Point-by-point Response to the Reviews

Interactive comment on “Optimizing High-Resolution Community Earth System Model on a Heterogeneous Many-Core Supercomputing Platform (CESM-HR_sw1.0)” by Shaoqing Zhang et al.

TABLE II
TAIHULIGHT SPECIFICATIONS AND BANDWIDTH MEASURED

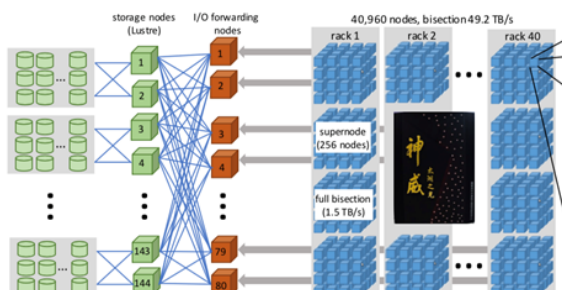
Lines 212-218 (170-175): The authors don't describe what the speed and bandwidth of connections between super-nodes, within a cabinet, and between cabinets. This is essential in understanding the limitations of the Sunway TaihuLight system at scale.

RE: Good comment! The TaihuLight compute nodes are connected via a 2-level InfiniBand network. A single-switch with full bisection bandwidth connects all 256 nodes within a super-node, while a fat-tree with 1/4 of the full bisection bandwidth connects all super-nodes (as shown the following Figure). Table II shows measurements of bisection communication bandwidth at different levels of the system.

Such essential information is added in the revision. Please see L175-178. Thanks.
